Commonwealth Edison
One First National Plaza, Chicago, Illinois
Address Reply to: Post Office Box 767
Chicago, Illinois 60690

Mr. Dennis L. Ziemann, Chief
Operating Reactors - Branch 2
Division of Operating Reactors
U.S. Nuclear Regulatory Commission
Washington, D.C. 20555

Subject: Dresden Station Unit 2
ECCS Appendix K Single Failure Analysis
NRC Docket No. 50-237

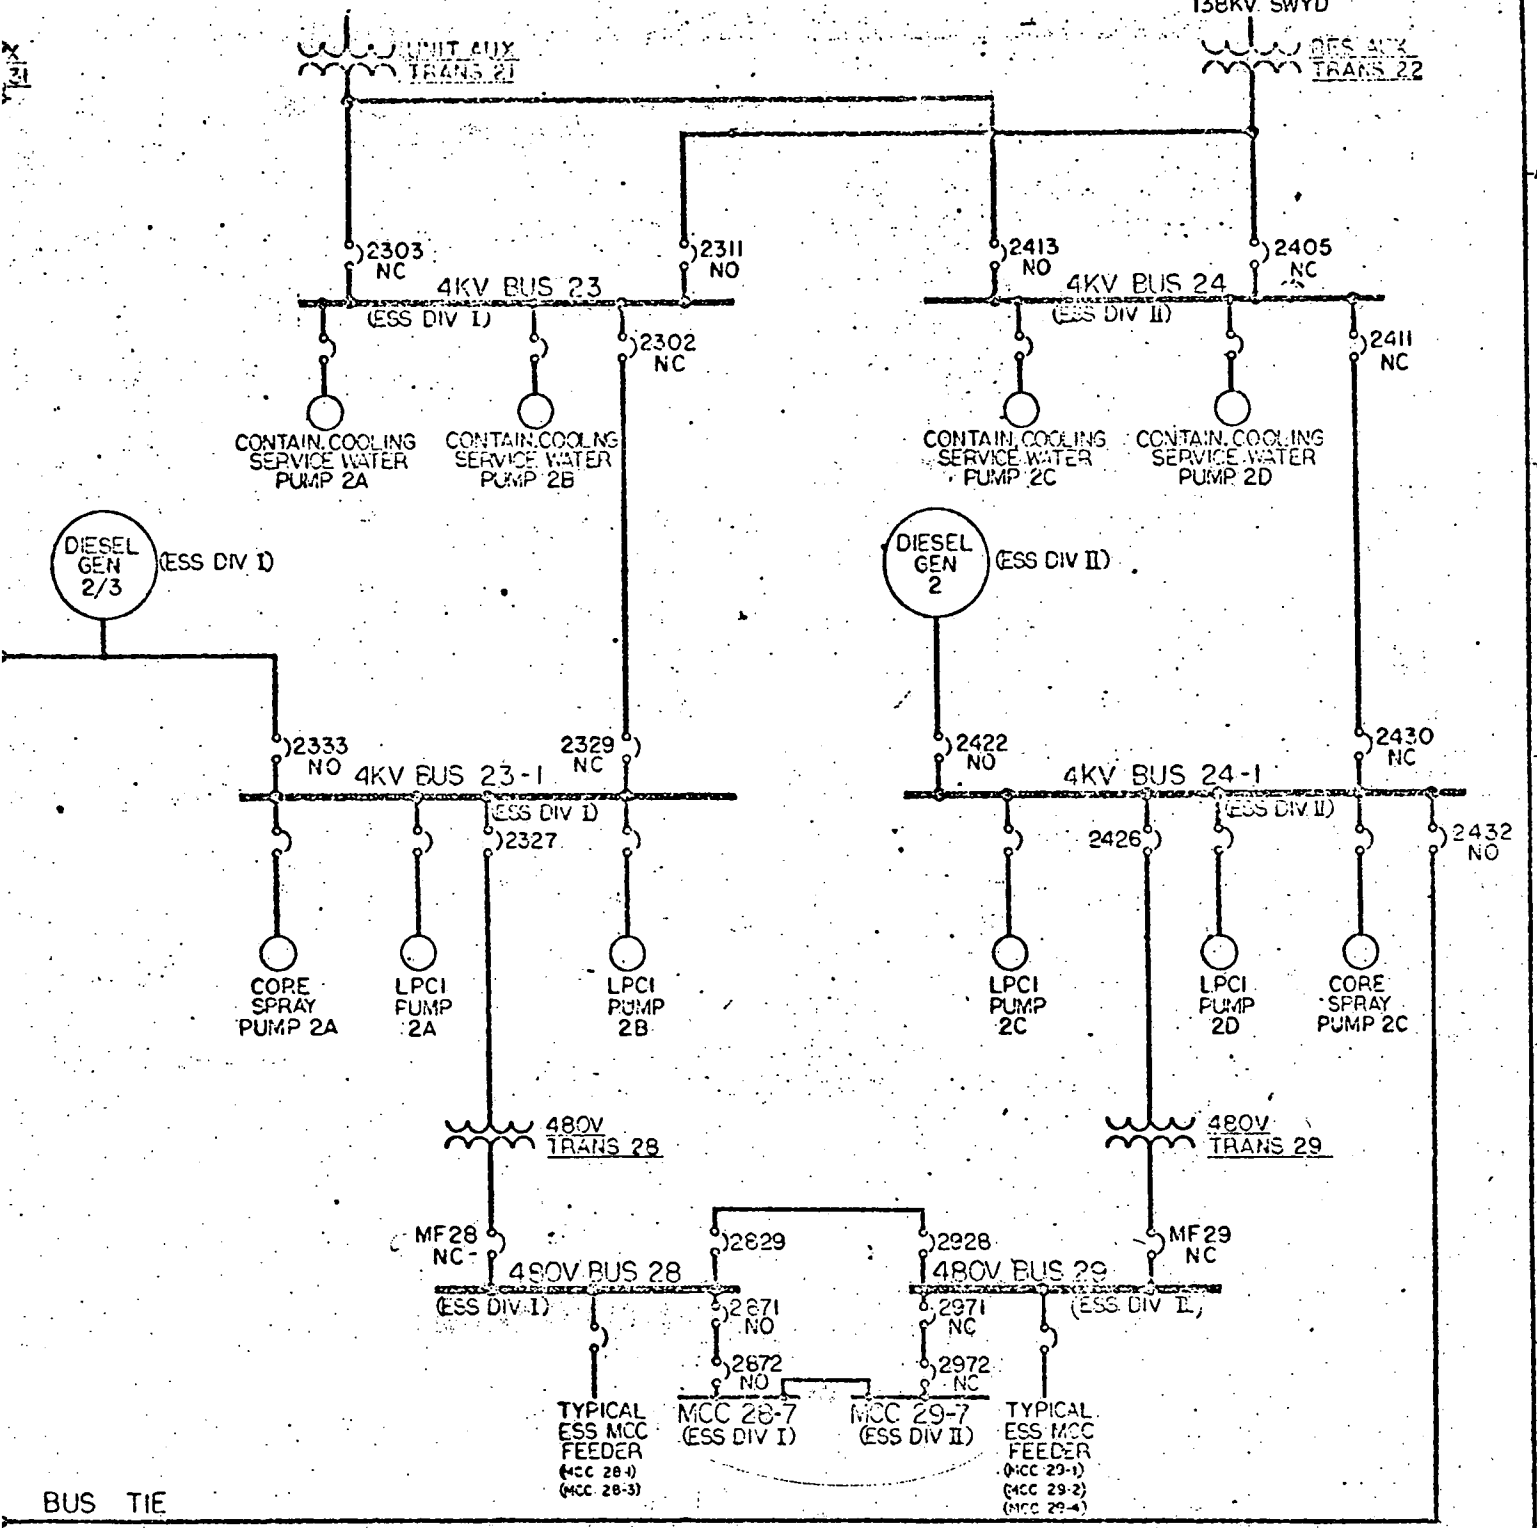
6. Description of the individual controls for feeds to Bus 28 and Bus 29 and their crossties to prevent paralleling of Bus 28 and Bus 29 are provided below. Refer to drawing 12E 2328 for location of breaker by number.

Bus 28 - Main Feed Breaker ACB 242-MF28

This electrically operated breaker is manually controlled by a control switch located at Main Control Board Panel No. 902-8 only. Note that a single (common) switch is used to control 4160 volt breaker 152-2327 and 480 volt breaker 252-MF28.

The interlocks with the transformer 4160 volt supply ACB 152-2327 are such that; i.e., 480 volt Bus 28 main feed ACB 252-MF28 cannot be closed unless the 4160 volt breaker is first closed and it is automatically tripped when the 4160 volt breaker is tripped. This breaker does not close automatically.

Bus 28 - Tie to 480 Volt Switchgear Bus 29 ACB 252-2829

This electrically operated breaker is manually controlled by a control switch located at Main Control Board Panel 902-8 only and does not close automatically.

The breaker 252-2829 can be closed manually by means of the control switch provided that either:

- A. Breaker 252-MF28 is closed with breaker 252-MF29 open, or,
- B. Breaker 252-MF28 is open with breaker 252-MF29 closed.

Bus 29 - Main Feed ACB 252-MF29

This electrically operated breaker is manually controlled by a control switch located at Main Control Board Panel No. 902-8 only. Note that a single (common) switch is used to control 4160 volt breaker 152-2426 and 480 volt breaker 252-MF29.

The interlocks with the transformer 4160 volt supply ACB 152-2426 are such that 480 volt Bus 29 main feed ACB 252-MF29 cannot be closed unless the 4160 volt breaker is first closed and it is automatically tripped when the 4160 volt breaker is tripped. This breaker does not close automatically.

Bus 29 - Tie to 480 Volt Switchgear Bus 28 ACB 252-2928

The breaker ACB 252-2928 can be closed by means of the control switch on panel 902-8 provided that:

- A. ACB 152-2327 is open and ACB 152-2426 is closed, or,
- B. ACB 152-2327 is closed and ACB 152-2426 is opened.

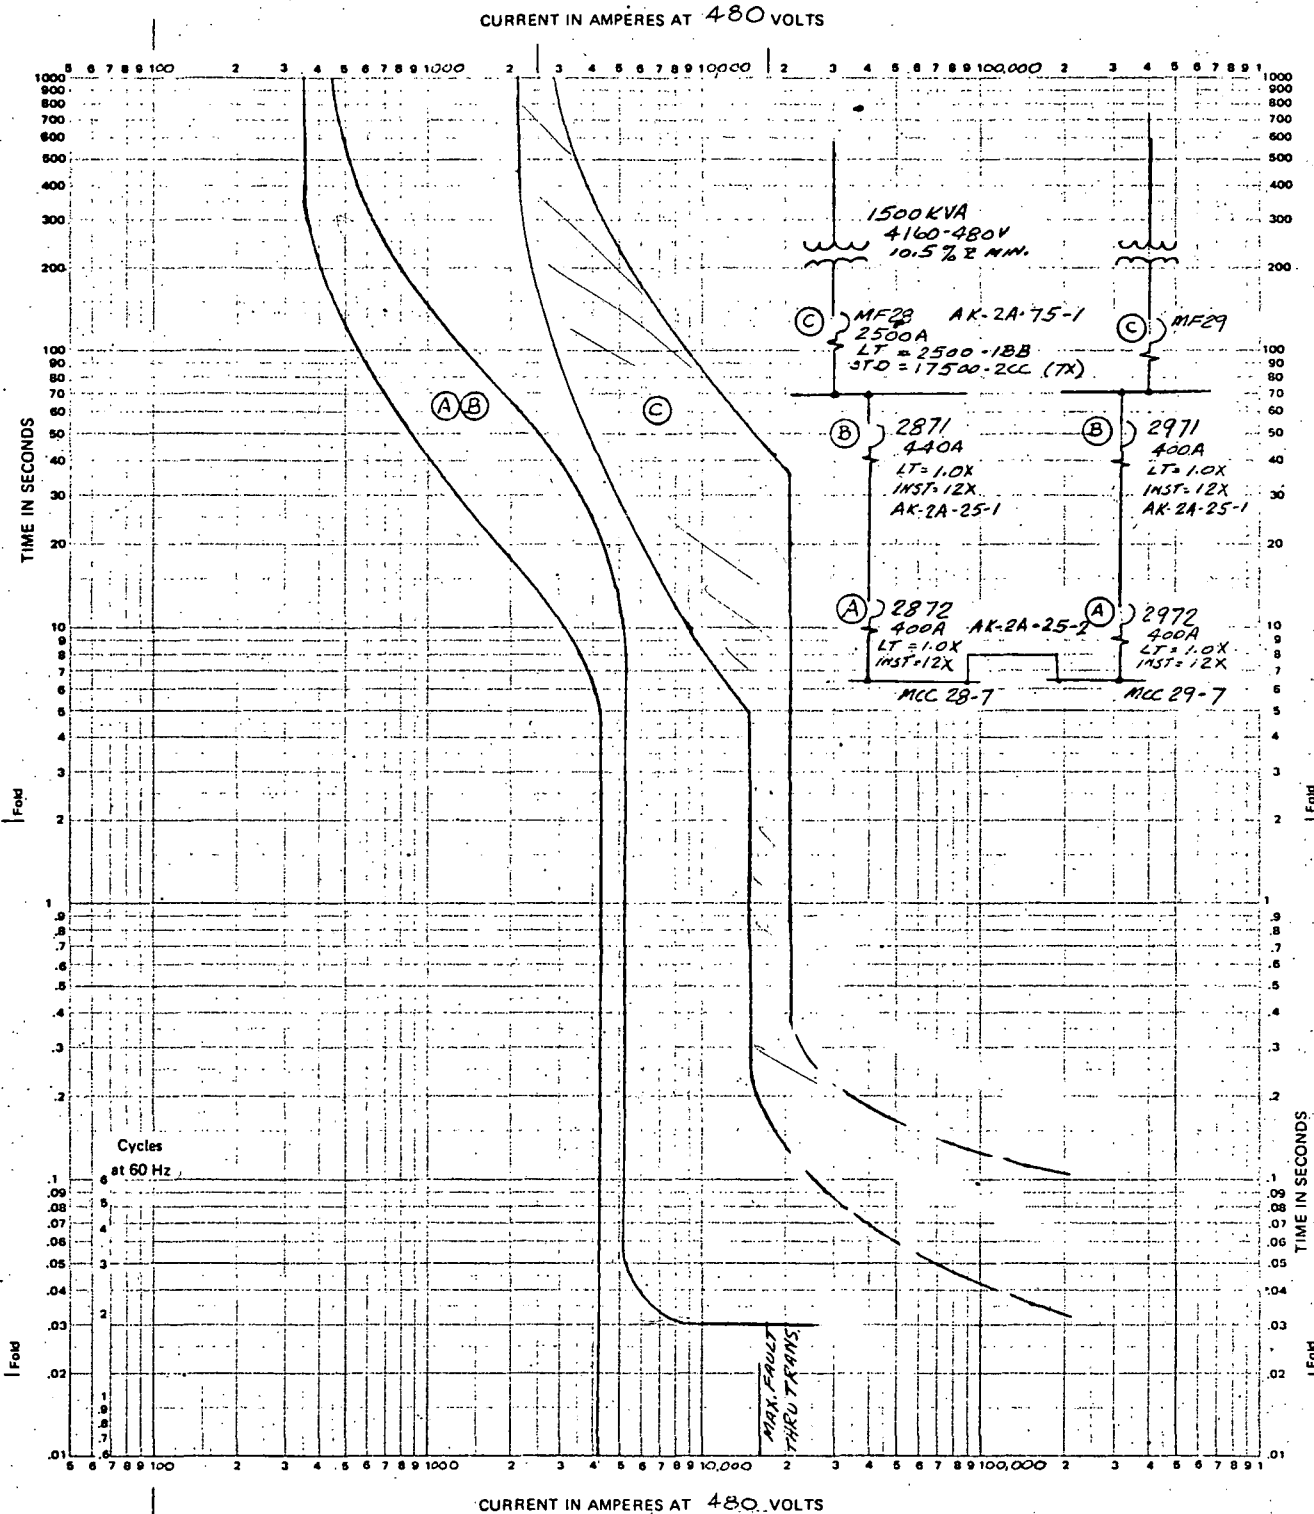
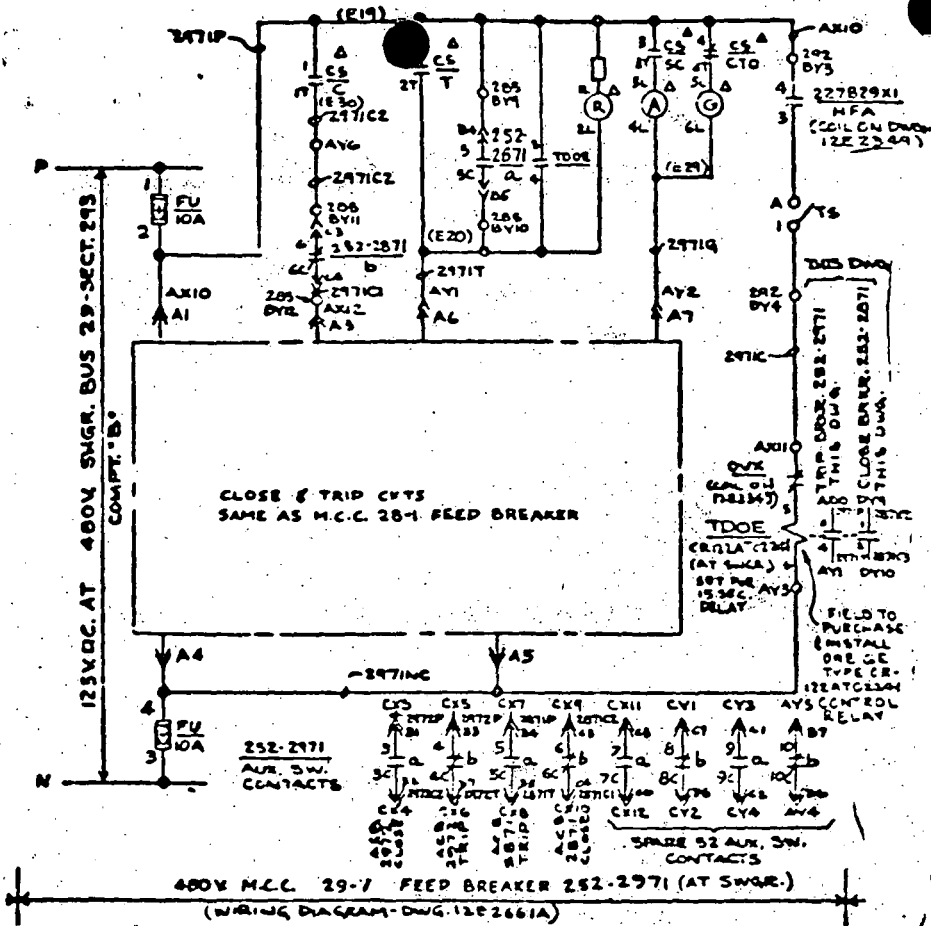
9. The interlock and automatic transfer details between 480v Buses 28 and 29 for the LPCI valve buses 28-7/29-7. Refer to 12E-2328 for breaker location by number.

The normal feed to MCC 28/7 - 29/7 is from 480v AC Bus 29. Should under voltage develop on Bus 29 for 15 seconds an automatic transfer to Bus 28 is initiated. The 15 second time delay prevents a premature transfer while the diesel generator is coming up to speed in the event of loss of all off-site power.

After the time delay relay times out, Breaker 2971 at Bus 29 will trip. Auxiliary contacts from Breaker 2971 will close 2871 (in conjunction with low voltage on Bus 29) and will trip Breaker 2972. Breaker 2872 will close automatically when breaker 2871 is closed and breaker 2972 is open.
